**CALIFORNIA COASTAL COMMISSION**

May 28, 2003

RE: **Notice of Impending Development 5-03, Pursuant to the University of California Santa Barbara Certified Long Range Development Plan (LRDP)** for Public Hearing and Commission Action at the meeting of June 13, 2003, in Long Beach.

**SUMMARY AND STAFF RECOMMENDATION**

<b>EXHIBIT 2</b>
<b>UCSB NOID 5-03</b>
<b>Potential Bldg Locations</b> (Fig 12 of the LRDP)

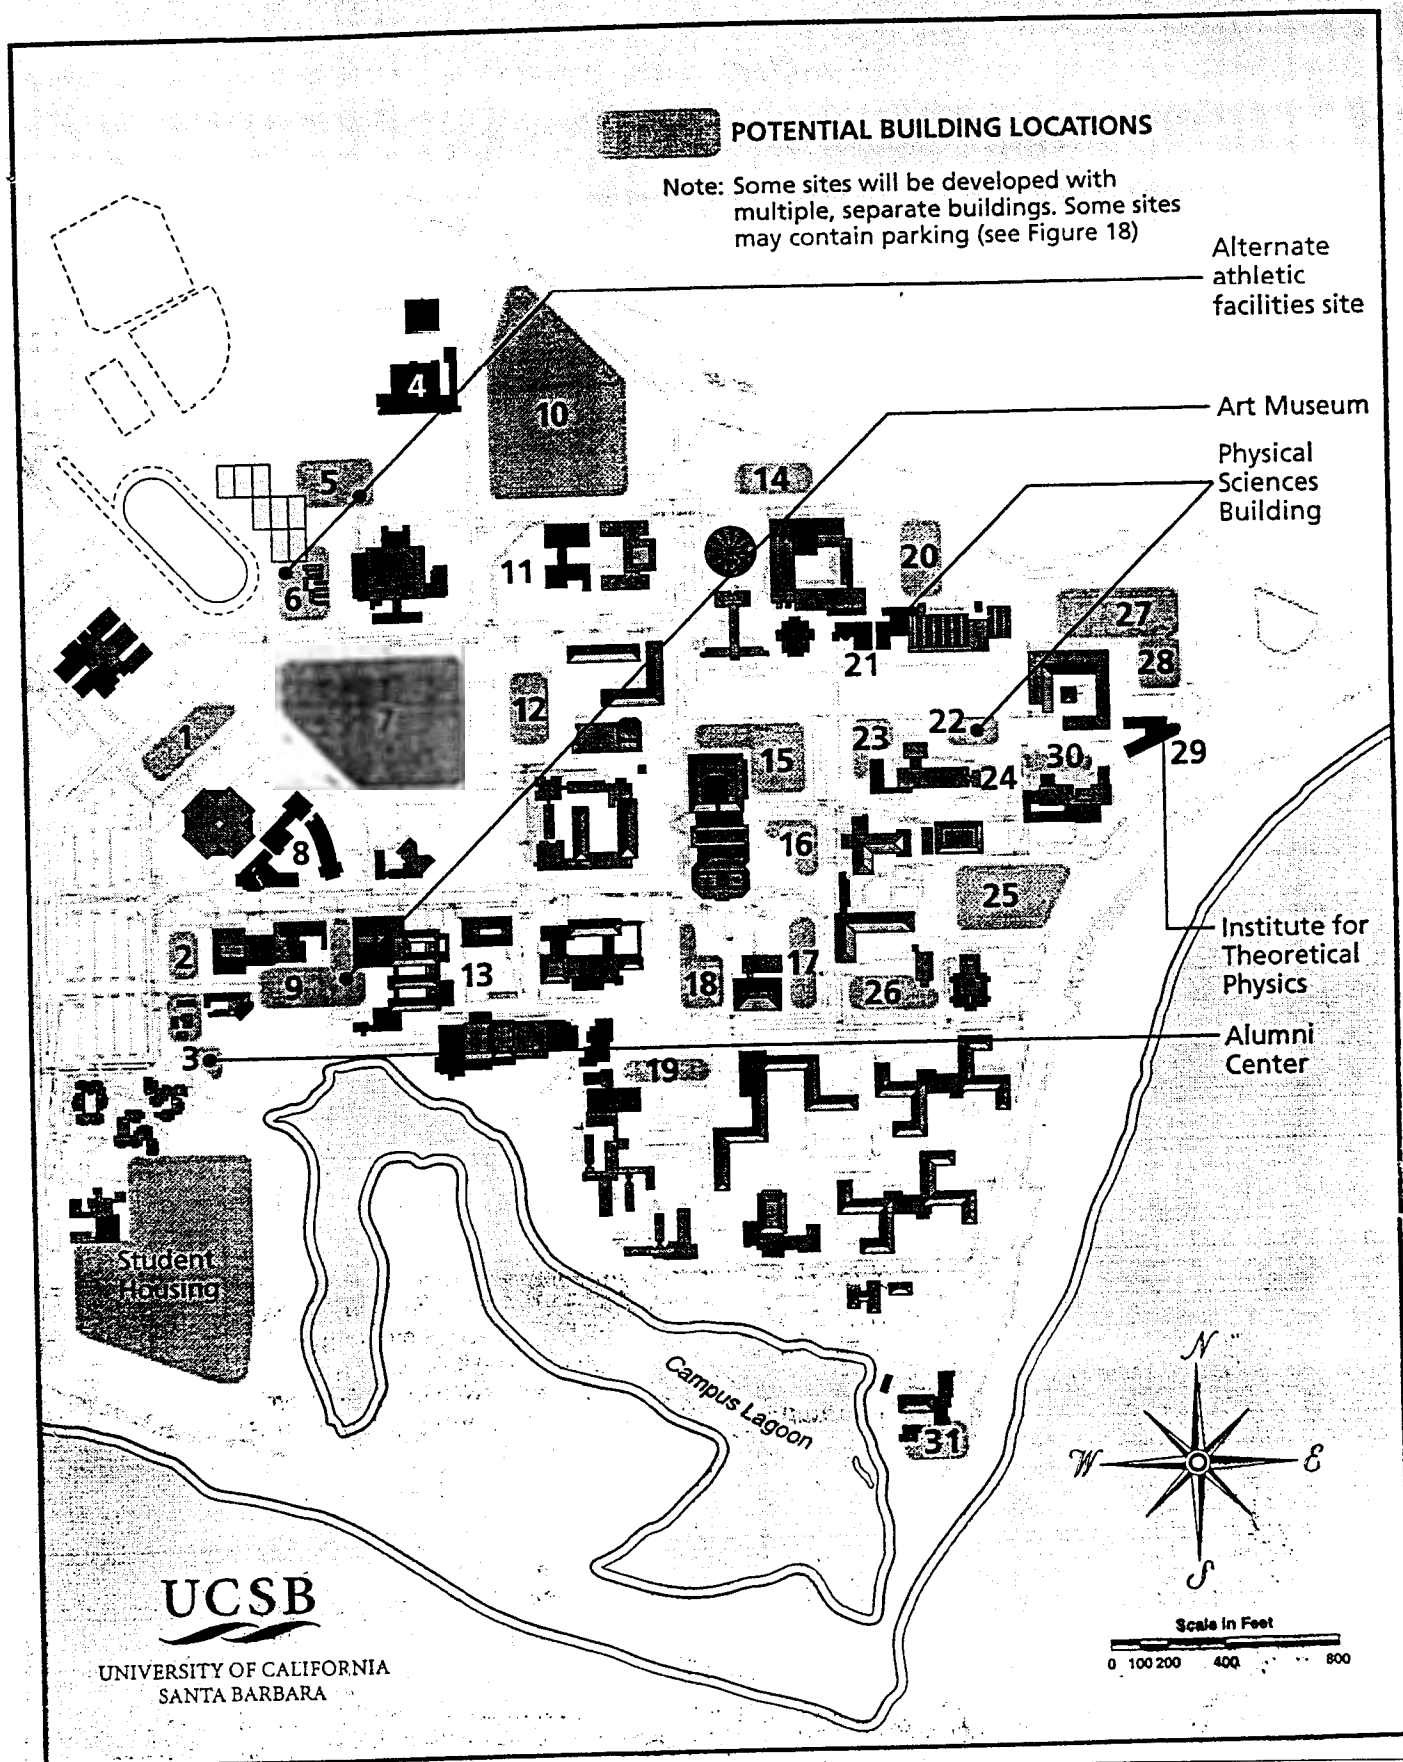
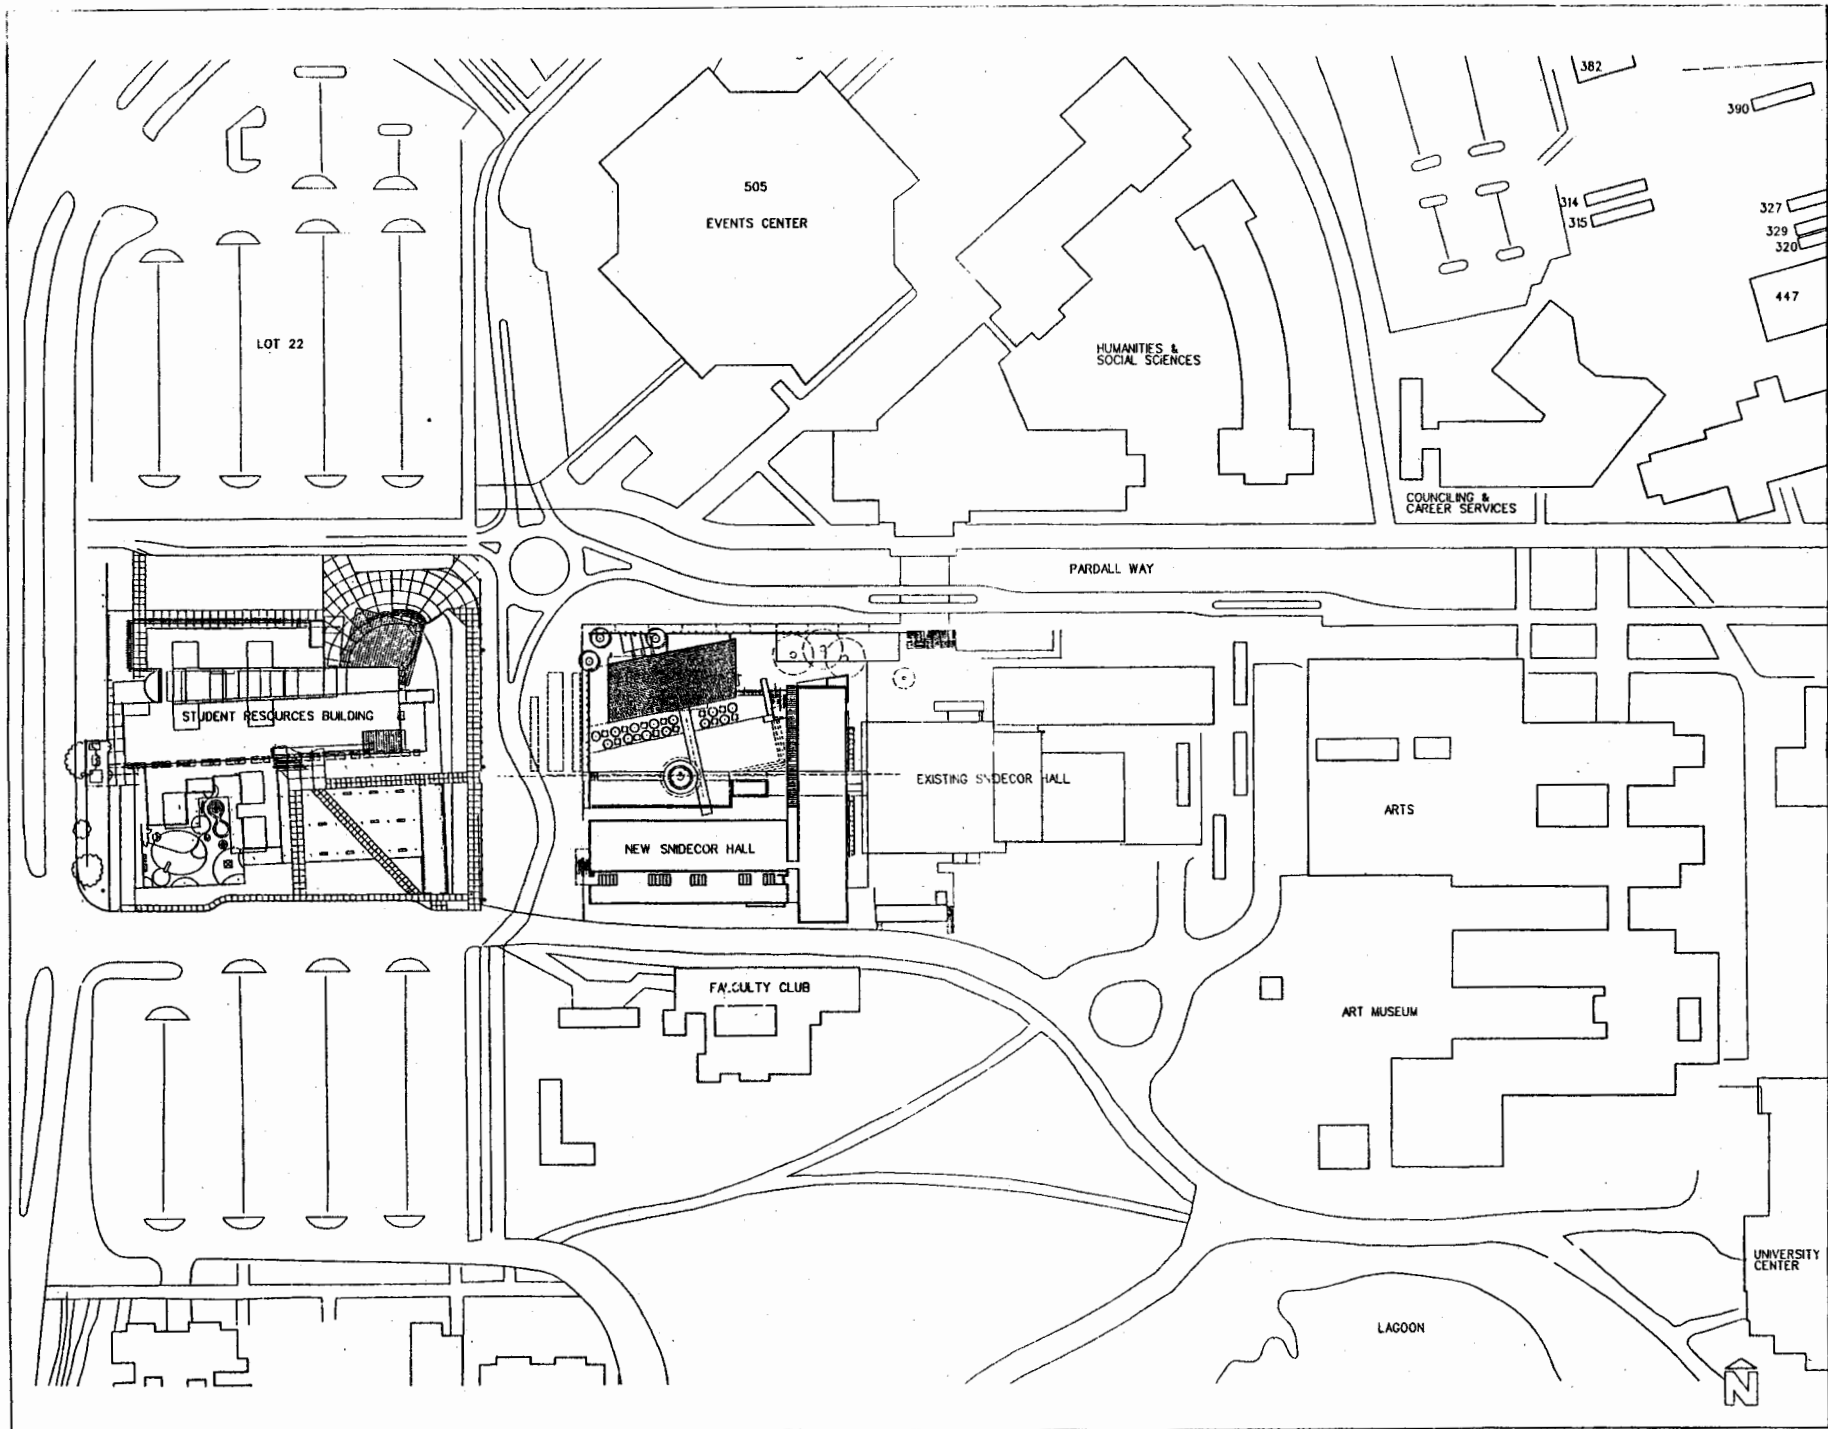
Potential new building locations, uses, and building area guidelines have been designated in the certified LRDP. The proposed project site is located on identified Potential Building Site No. 2 (Exhibit 2). The certified UCSB LRDP indicates that the project site may be developed with a range of different potential uses including: (1) expansion of Snidecor Hall (speech, hearing, dramatic arts and dance), (2) expansion of Faculty Club recreation amenities, or (3) campus community serving function befitting location to parking, faculty club, and visibility from campus periphery. The proposed project is intended to address identified seismic and life safety problems and to meet the research needs of the campus, including instruction and research space for the Department of Dramatic Arts, and general assignment classroom space. The use of this facility to support the expansion of Snidecor Hall is consistent with the location and building uses designated in the LRDP.
